Technical Guidance Committee Meeting

Agenda*

Friday March 20, 2015

**Department of Environmental Quality
Conference Room C
1410 North Hilton
Boise, Idaho**

Figure 2-2. Soil texture determination flowchart.

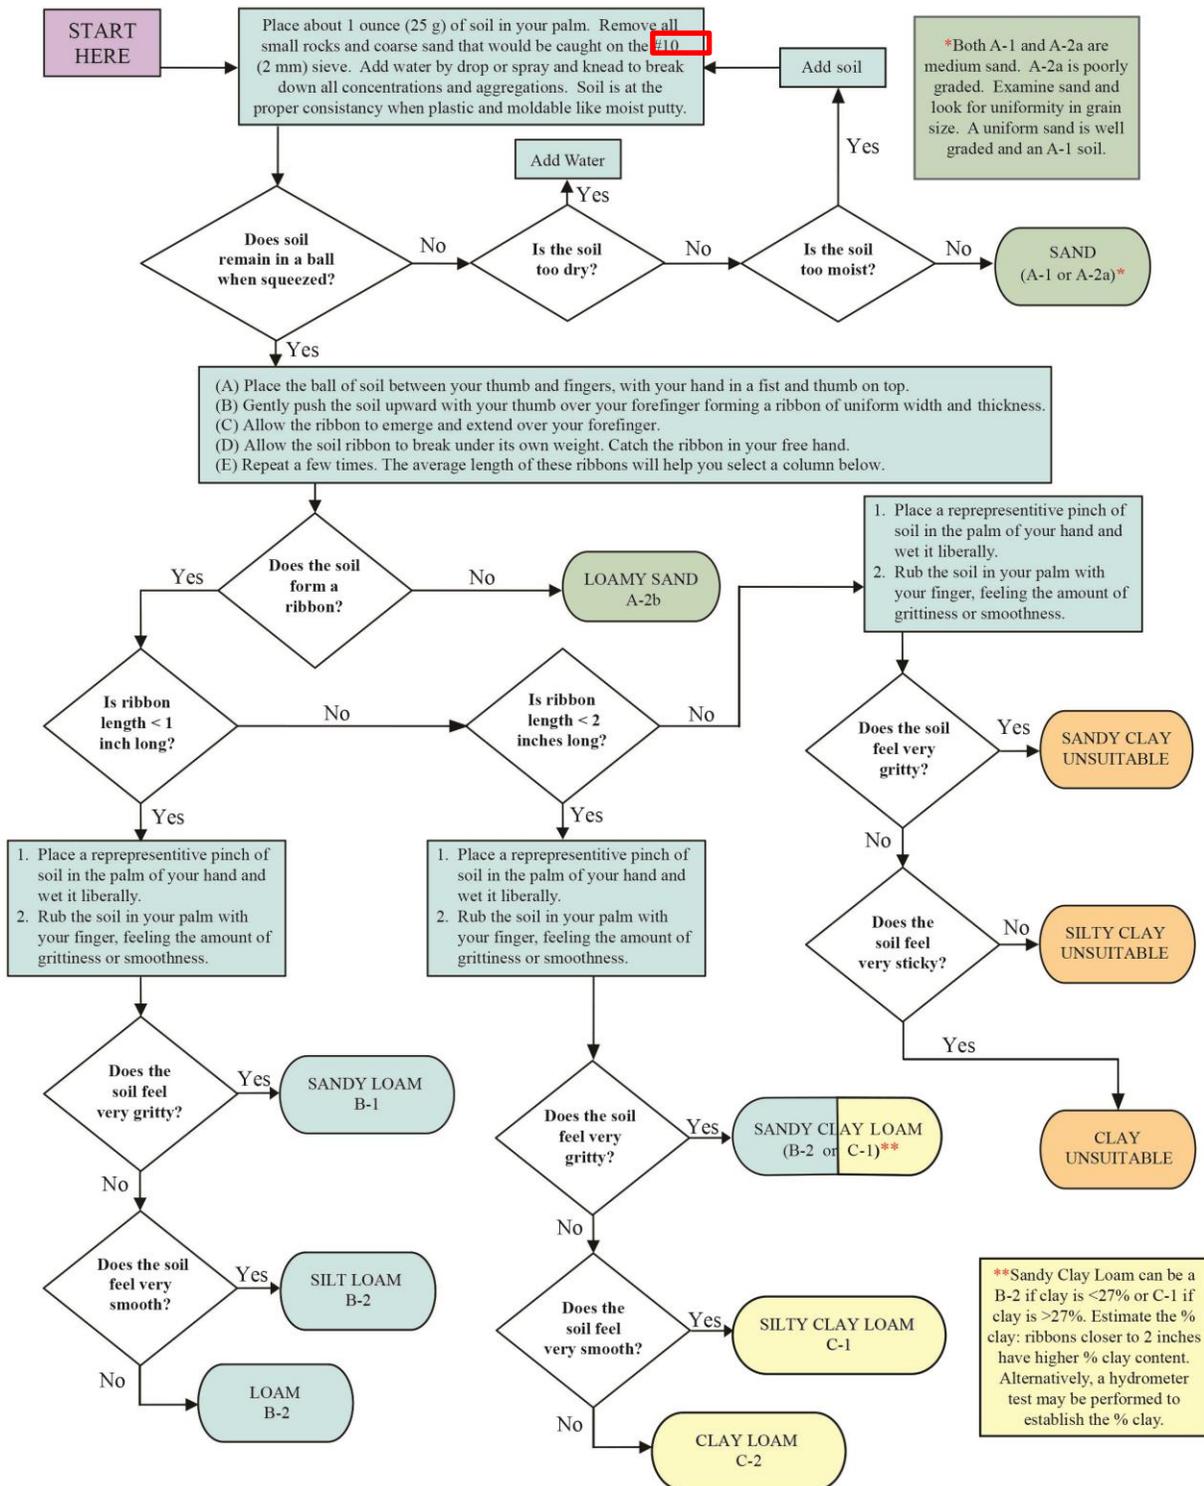
- 1:00 PM Figure 2-2 Soil Texture Determination Flowchart (**Appendix I**)
- Discussion on amendment of #10 sieve (2 mm) to #50 sieve (0.297 mm) for removal of all unsuitable material prior to texturing. Review for preliminary approval.
